Access Compliance Report

Public Rights-of-Way

(Curb Ramps)

Intersection ID: 10740	Main Street: PRYOR_ST	Cross Street: TUCKASEEGEE_RD	Location: W
ADA ID: 756AF57D49AD	Ramp Type: Perp	Initial Pass/Fail: Fail	Overall Compliance: No
Severity Score: 12.5			
Codes/Mitigation Info/Possible Solution		Field Measurements/Component Compliance

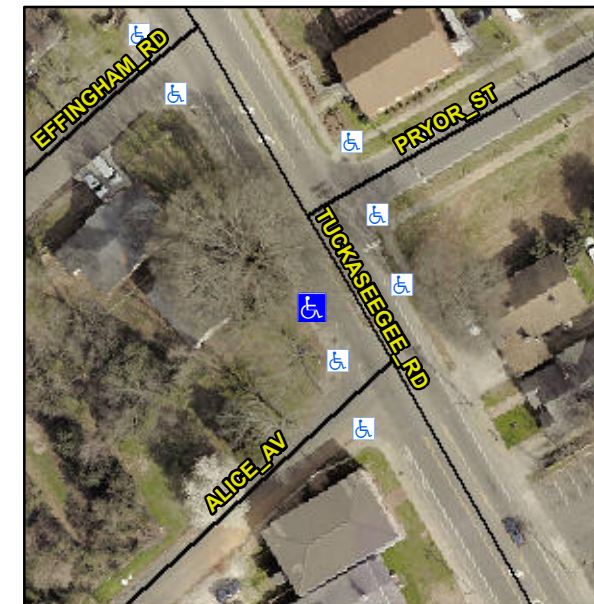
Not Found, R304.2.2

Compliance	Description	Data	Compliance	Description	Data
N/A	Ramp Length (in)	67.0	No	Ramp Slope (%)	11.4
Yes	Ramp Width (in)	48.0	Yes	Ramp XSlope (%)	0.8
N/A	Flare Type LT	N/A	N/A	Flare Type RT	N/A
N/A	Flare Slope LT (%)	N/A	N/A	Flare Slope RT (%)	N/A
N/A	Flare Traversable LT?	N/A	N/A	Flare Traversable RT?	N/A
N/A	Landing Length (in)	N/A	N/A	DWS Provided?	N/A
N/A	Landing Width (in)	N/A	N/A	DWS Contrast?	N/A
N/A	Landing Slope (%)	N/A	N/A	DWS Length (in)	N/A
N/A	Landing X Slope (%)	N/A	N/A	DWS Full Width?	N/A
N/A	Landing Curb? (Y/N)	N/A	N/A	DWS Offset (in)	N/A
N/A	Shared Landing?	N/A			
N/A	Gutter Ponding?	Yes	N/A	Gutter Slope (%)	N/A
N/A	Gutter Lip Ht (in)	N/A	N/A	Gutter X Slope (%)	N/A
N/A	Painted X Walk1?	No	N/A	Painted X Walk2?	N/A
	X Walk 1 Direction	To E		X Walk 2 Direction	N/A
N/A	X Walk 1 Width (in)	N/A	N/A	X Walk 2 Width (in)	N/A
	X Walk 1 Slope (%)	7.2		X Walk 2 Slope (%)	N/A
	X Walk 1 X Slope (%)	0.8		X Walk 2 X Slope (%)	N/A

Remove & Replace Entire Ramp.
